**Economic Commission for Europe**

**Group of Experts on Road Signs and Signals**

**Proposal for amendments to Annex 1 and 3**

**Submitted by the secretariat and the Chair**

**SPEED HUMP**

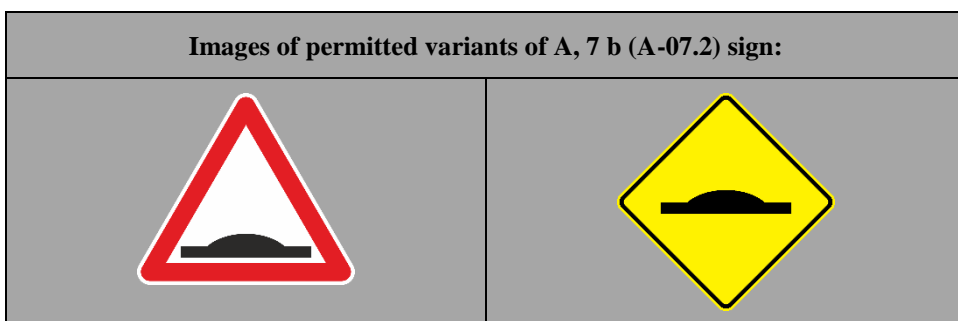
A, 7 b (A-07.2) gives warning of a a speed hump.

### LOOSE GRAVEL

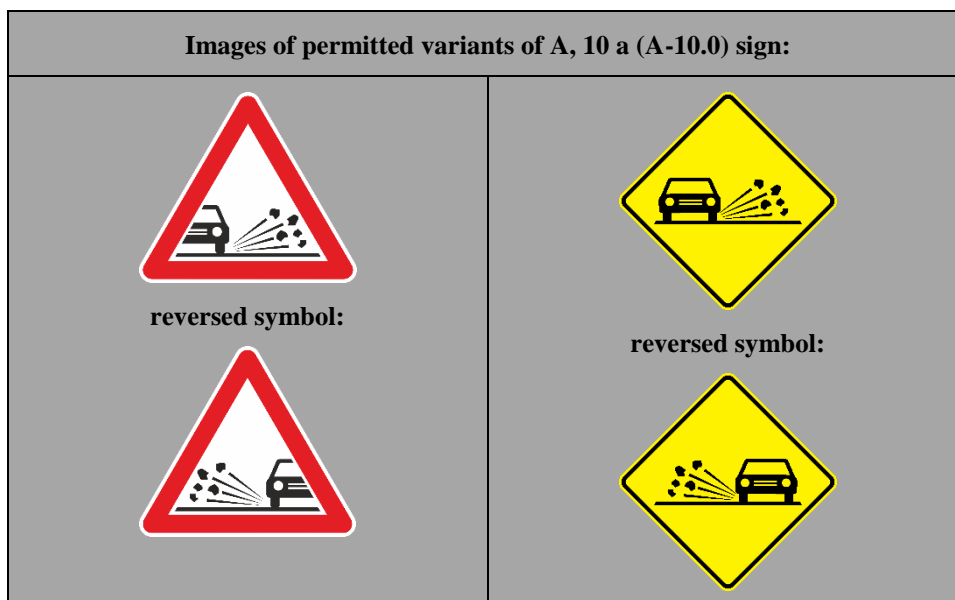
~~Warning of a section of road on which gravel may be thrown up shall be given by symbol A, 10a used with the sign of model Aa or by symbol A, 10b with the sign of model Ab.~~

**A, 10 a (A-10.0) gives warning of a section of road on which gravel may be thrown up. The symbol on this sign may be reversed.**

### FALLING ROCKS

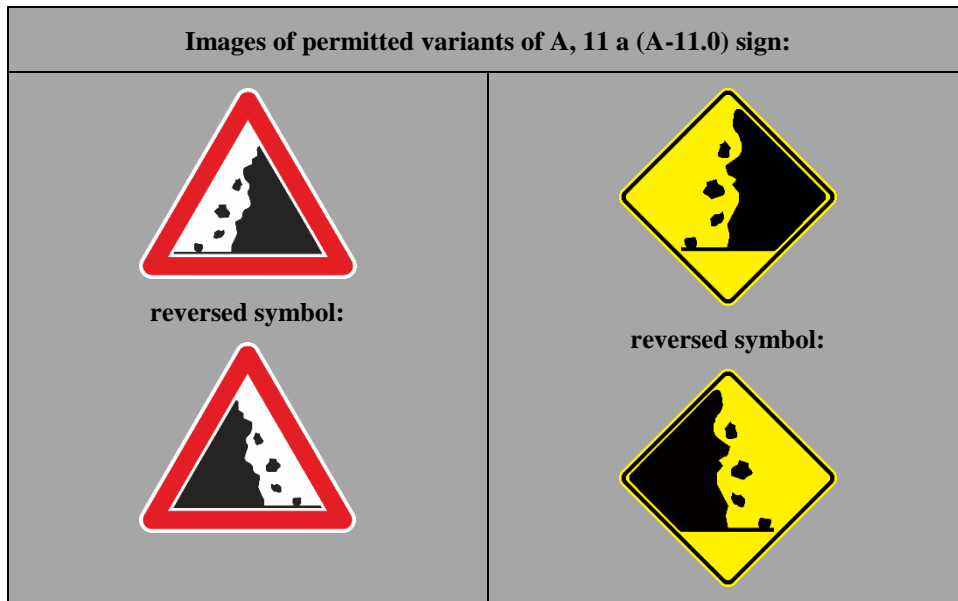
~~(a) Warning of a section of road on which there is danger from falling rocks and the consequent presence of rocks on the carriageway shall be given by symbol A, 11a used with the sign of model Aa or by symbol A, 11b with the sign of model Ab.~~

~~(b) The right hand part of the symbol shall occupy the right hand corner of the sign panel in both cases.~~

~~(c) The symbol may be reversed.~~

**A, 11 a (A-11.0) gives warning of a section of road on which there is danger from falling rocks and the consequent presence of rocks on the carriageway. The symbol on this sign may be reversed.**

**TRAFFIC LIGHT SIGNALS**

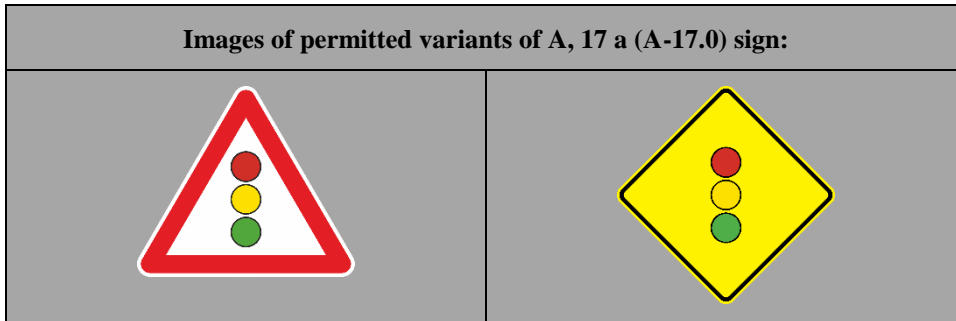
~~(a) If it is considered essential to give warning of a section of road on which traffic is regulated by three colour light signals, because road users would not expect such a section, symbol A, 17 shall be used. There are three models of symbol A, 17: A, 17a ; A, 17b ; and A, 17c , which correspond to the arrangements of lights in the three colour system described in Article 23, paragraphs 4 to 6 of this Convention.~~

~~(b) This symbol shall be in the three colours of the lights of which it gives warning.~~

A, 17 (A-17.0) gives warning of a section of road on which traffic is regulated by three-colour traffic light signals. The symbol of traffic light signals shall be surrounded by a dark colour narrow strip.

This sign shall only be used on road sections on which road users would not expect traffic light signals. The symbol shall be in the three colours of the traffic lights of which it gives warning.

This sign may be set up to supplement or replace the signs described in paragraphs 18 to 21 if traffic at the intersection is regulated by a traffic light signal.

**TUNNEL**

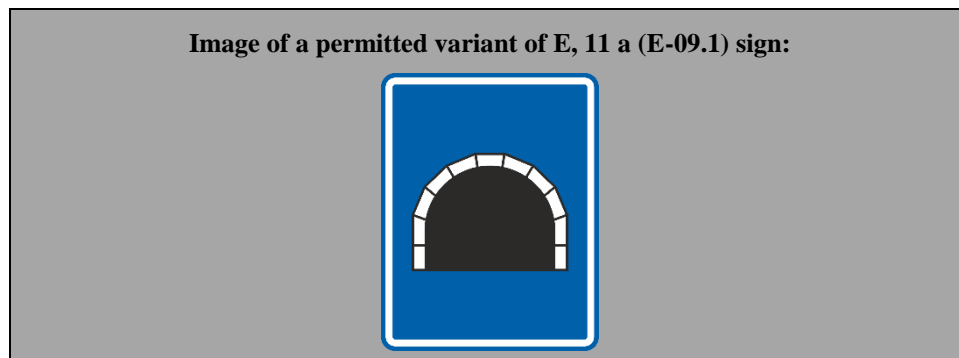
(a) ~~Sign~~ E, 11 a (E-09.1) ‘**TUNNEL**’ ~~notifies of~~ **indicates** a section of road passing through a tunnel ~~and~~ on which special traffic rules apply. It is placed at the point from which these rules apply. **It shall be used for tunnels of 1,000 m or more and in cases provided for by domestic legislation. The length of such tunnel shall be included either in the lower part of the sign or on an additional panel H, 2 (H-02.0) as described in section H, subsection II paragraph 1. The name of the tunnel may be placed on an additional panel or on the sign itself.**

(b) In order to warn road users in advance, sign E, 11a (E-09.1) may be placed in addition, at a suitable distance before the point where the special rules apply; such sign shall show, either in its lower part, or on an additional panel H, 1 (H-01.0), as described in section H, **subsection II paragraph 1** ~~paragraph 2 (a) of this Annex~~, the distance between the point at which it is set up and the point from which these special rules apply.

#### END OF TUNNEL

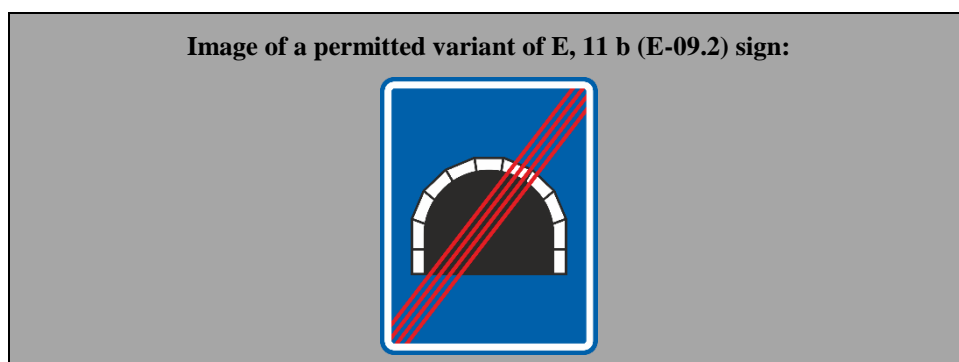
(c) ~~Sign E, 11b (E-09.2) 'END OF TUNNEL'~~ **notifies that the special traffic rules imposed by sign E, 11 a (E-09.1) may be placed at the point from which the special rules no longer cease to apply from the point of its placement. This sign shall be identical to E, 11 a (E-09.1) except that it shall be crossed by a diagonal red band or, preferably, of red parallel lines forming such a band running from the upper right edge to the lower left edge. The diagonal band may be interrupted when crossing the symbol. If not interrupted, the diagonal band shall be placed over the symbol.**
